REMARKS

Drawing Objections

ANNOTATED SHEET
Application No. 10/769,388 -- Attorney Docket No. 019680-007200US

Fig. 3

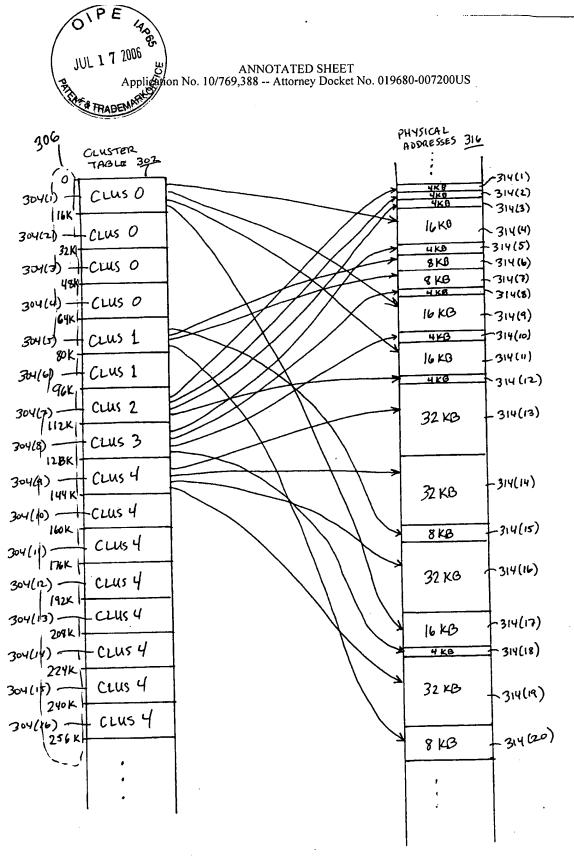
The Examiner has objected to Figure 3 for failing to comply with 37 C.F.R. §1.84(p)(5). Figure 3 has been amended to include reference number 306. Applicants have further amended Figures 1, 10, 20 and 24 to include appropriate reference numbers and flow diagram labels as shown in red on the attached Annotated Sheets. Withdrawal of the objection to the drawings is respectfully requested.
